**Comments on the  
New Mexico Environment Department Ground Water Quality Bureau  
Draft Ground Water Discharge Permit DP-200 Renewal and Modification**

George Rice  
January 21, 2014

**Comments on the  
Decommissioning and Reclamation Plan Update 2013, SUA-1471, Homestake Grants  
Reclamation Project, Cibola County, New Mexico, April 2013**

**Comments on the  
Grants Reclamation Project, Updated Corrective Action Program (CAP)  
Homestake Mining Company of California, March 2012**

**Figure 1**  
Updated with data for 2012

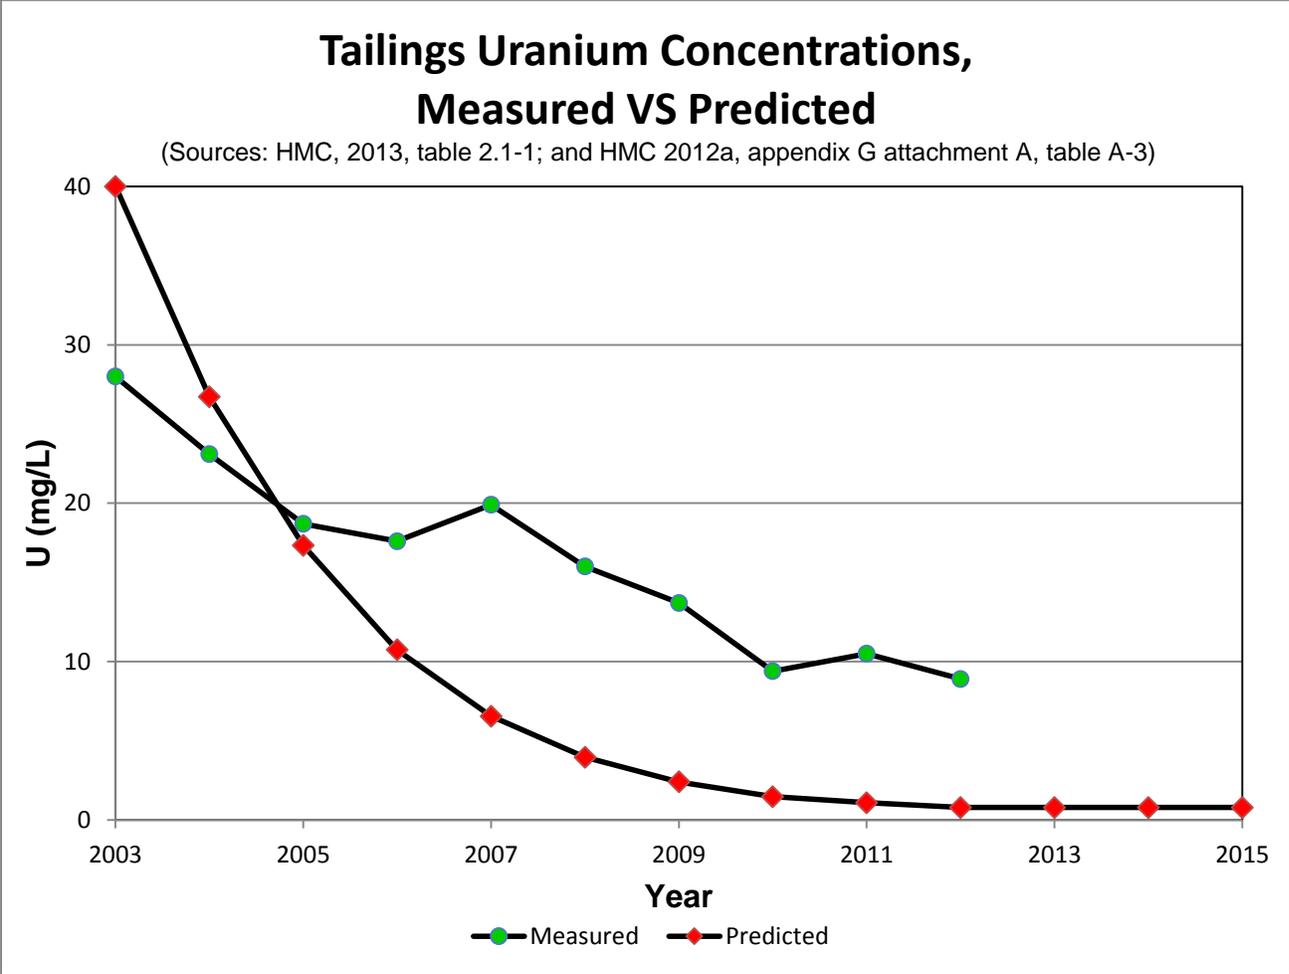
**2. Time required to flush contaminants from LTP**

HMC has not determined the length of time that the large tailings pile (LTP) will continue to contaminate underlying groundwater. HMC’s claims regarding the rate that contaminants will be flushed from the LTP are not supported by the data.<sup>24</sup> The figure below is an updated version of figure 1 in the BVDA/MASE comments.<sup>25</sup>

<sup>25</sup> Uranium concentrations in samples collected from the tailings pile toe drains are higher than concentrations in samples collected from the wells installed in the tailings (the data in figure 1 are from wells in the tailings). For example, the average uranium concentrations in toe drain samples from 2011 and 2012 were 29.9 mg/L and 26.8 mg/L, while the average concentrations in the wells were 10.5 mg/L and 8.9 mg/L, respectively (HMC, 2013, table 2.1-1). If toe drain concentrations were used in figure 1 instead of tailings well concentrations, the difference between the measured and predicted concentrations would be greater.

**Figure A-1**  
Background Uranium Concentrations in Upper Chinle Aquifer, Non-mixing Zone  
1982 – 2000

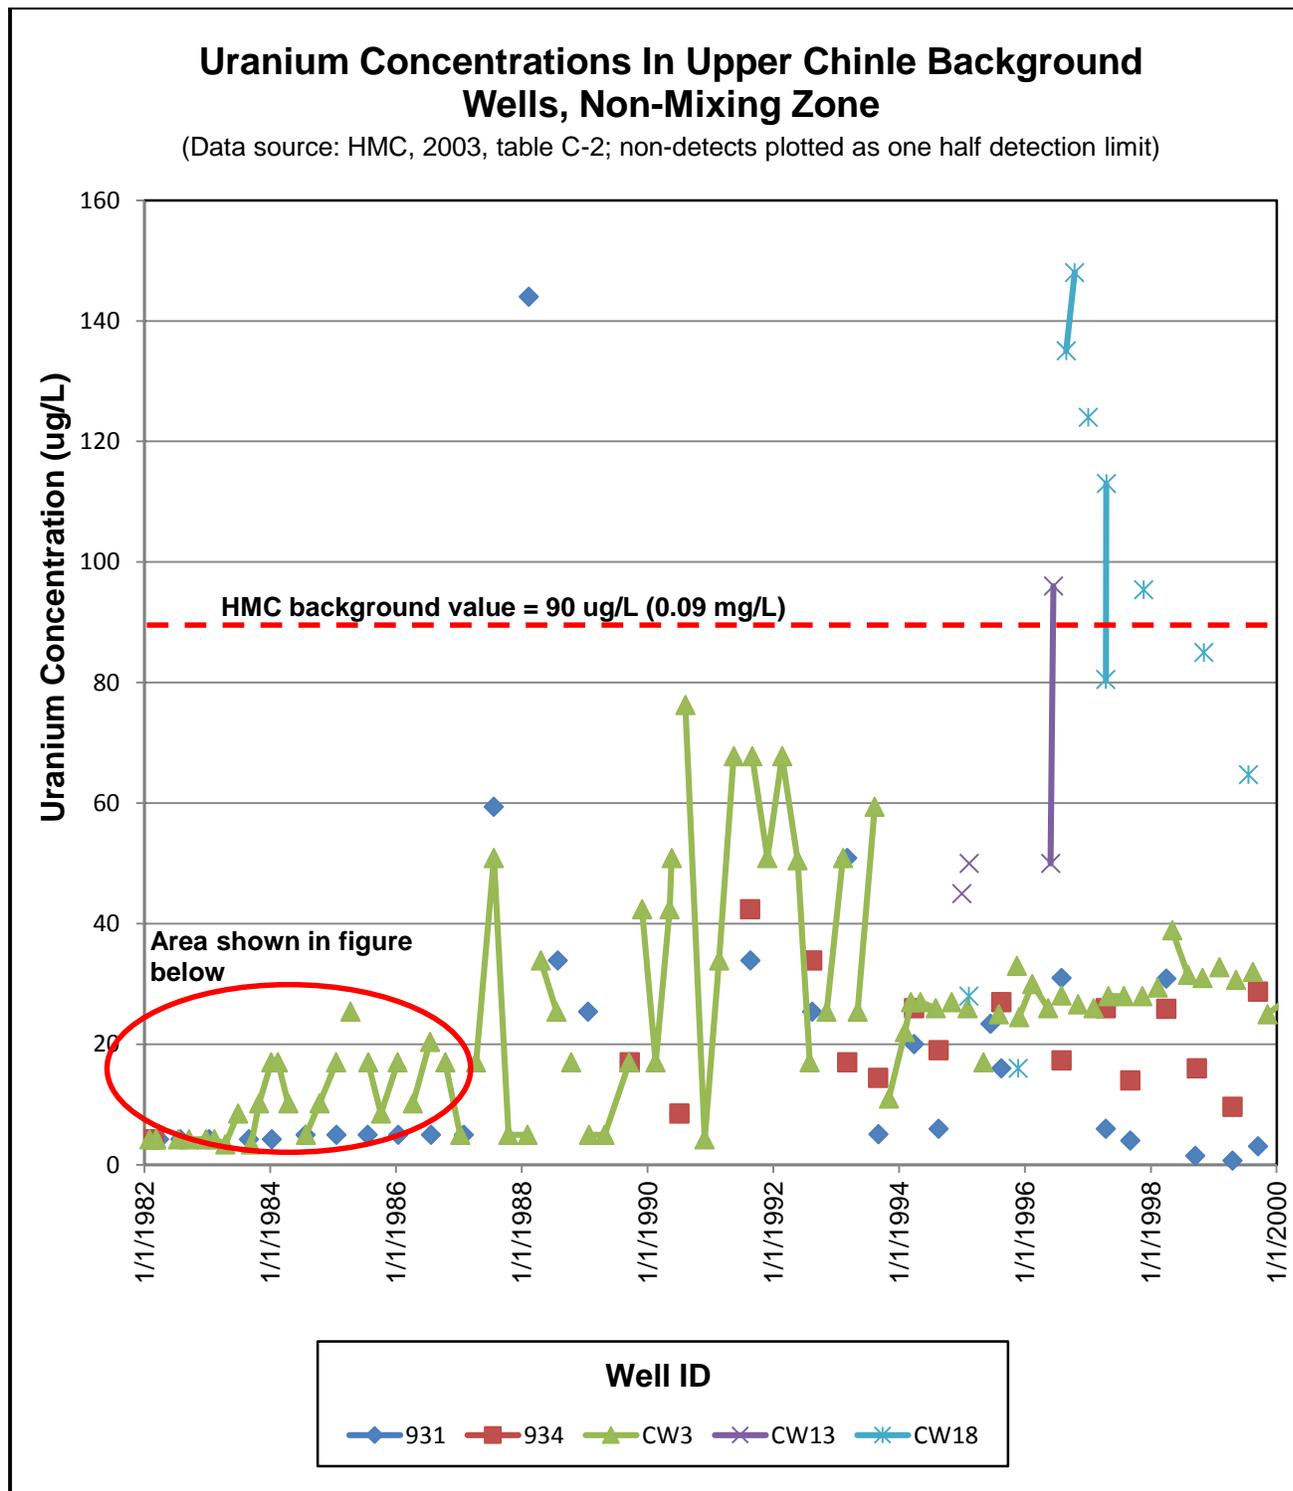
HMC claims that the background concentration of uranium in the Upper Chinle Aquifer is 90 µg/L.<sup>42</sup> However, during the first five years of sampling Upper Chinle background wells, no uranium concentrations exceeded 30 µg/L.<sup>43</sup> Only later did uranium concentrations rise (see figures A-1 and A-2 in appendix 1).<sup>44</sup> This raises the question: why did HMC include the later, higher, uranium concentrations in its estimate of the background concentration? It seems reasonable to estimate the background concentration using only uranium concentrations from earlier times, before the concentrations rose. HMC should explain why it included the later concentrations in its estimate of background.

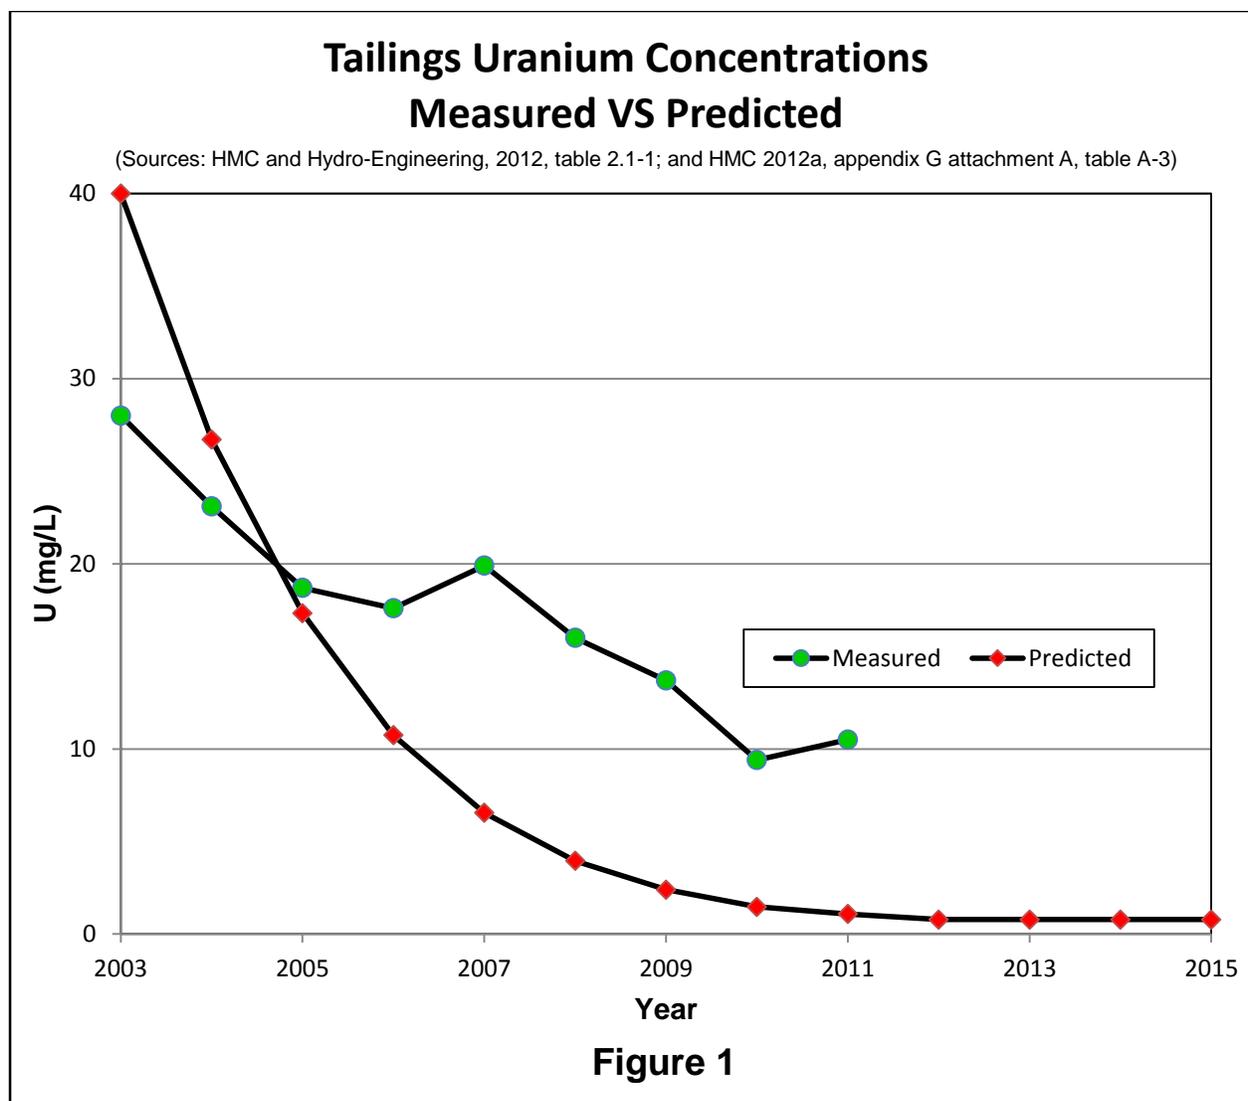
Finally, Homestake's predictions of uranium concentrations in the pile have not matched-up well with measured concentrations. This mismatch is illustrated in figure 1.
